Proposed Comment Resolution for the MR-O-QPSK PHY

IEEE P802.15

Title: Proposed Comment Resolution for the MR-O-QPSK PHY
Date Submitted: January 18, 2011
Source: Michael Schmidt - Atmel (email: michael.schmidt@atmel.com)
Re: Task Group 15.4g LB59 comment resolution
Abstract: Proposed comment resolution for the MR-O-QPSK PHY
Notice: This document has been prepared to assist the IEEE P802.15. It is offered as a basis for discussion and is not binding on the contributing individual(s) or organization(s). The material in this document is subject to change in form and content after further study. The contributor(s) reserve(s) the right to add, amend or withdraw material contained herein.
Release: The contributor acknowledges and accepts that this contribution becomes the property of IEEE and may be made publicly available by P802.15.

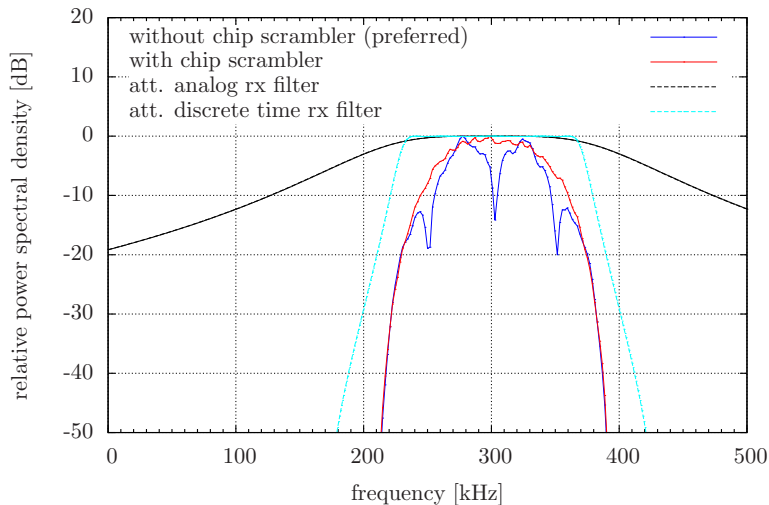
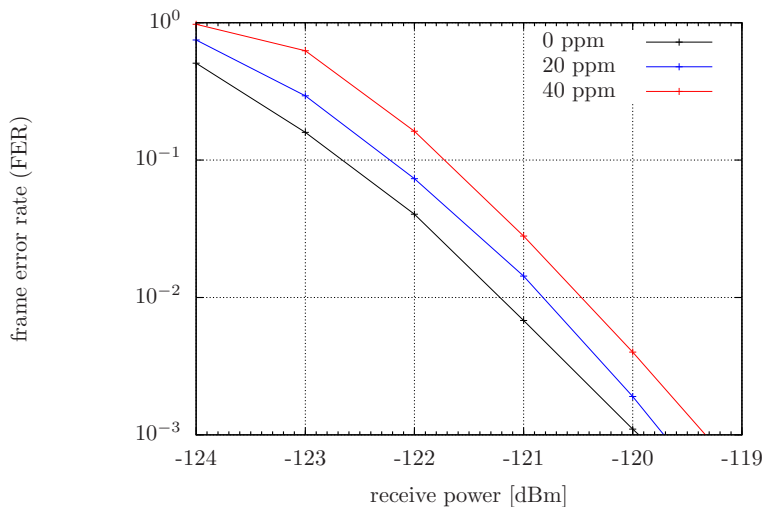
- ▶ Lower data rate should be considered in 470-510 MHz band for improved link budget.
- ▶ Add new data rate of 6.25 kbps with (8,1)-DSSS and rate 1/2 FEC.

IF:	300 kHz
analog receive filter:	2-nd order $f_{cut} = 100$ kHz
analog high pass filter:	2-nd order $f_{cut} = 50$ kHz
ADC:	6 bit at 4 MHz
discrete time receive filter:	FIR + 5-th order IIR ($f_{cut} = 62.5$ kHz)
LNA noise:	-174 dBm/Hz + 5 dB noise figure
carrier frequency:	868.3 MHz
crystal tolerance:	± 20 ppm

- ▶ true timing sync
- ▶ true frequency offset estimation

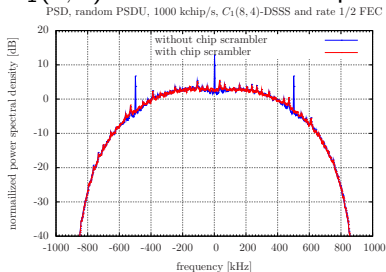
- ▶ Cross correlation of (8,4)-DSSS code is poor
- ▶ Non-coherent detection is not possible
- ▶ Consider (8,4)-DSSS code given in 15-10-0281-04-004g

- ▶ $C_0(8,4)$ is an extended BCH code.
- ▶ The distance properties of the inner block code are less relevant (due to outer rate 1/2 FEC).
- ▶ However, the coding gain of $C_0(8,4)$ can be exploited for a decision feedback based phase control loop³.

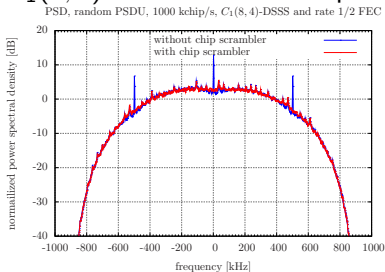
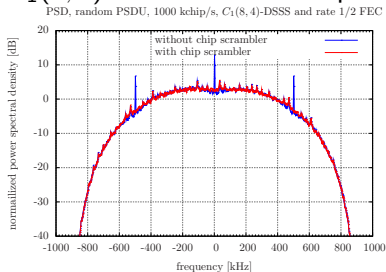
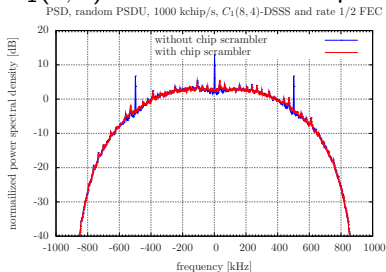
- ▶ $C_1(8, 4)$ shows noticeable spectral lines with a DC.

- ▶ relevant for operation at max. power in 902-928 MHz band (FCC §15.247: spectral density limit of 8 dBm/3 kHz).

- ▶ relevant for operation at max. power in 902-928 MHz band (FCC §15.247: spectral density limit of 8 dBm/3 kHz).
- ▶ DC and spectral lines can be removed by chip whitening, see P802.15.4g/D2 6.12c.1.11.

- ▶ relevant for operation at max. power in 902-928 MHz band (FCC §15.247: spectral density limit of 8 dBm/3 kHz).
- ▶ DC and spectral lines can be removed by chip whitening, see P802.15.4g/D2 6.12c.1.11.
- ▶ However, any possible advantage of $C_1(8, 4)$ with regard to multipath robustness is nearly lost once chip whitening needs to be introduced anyway.
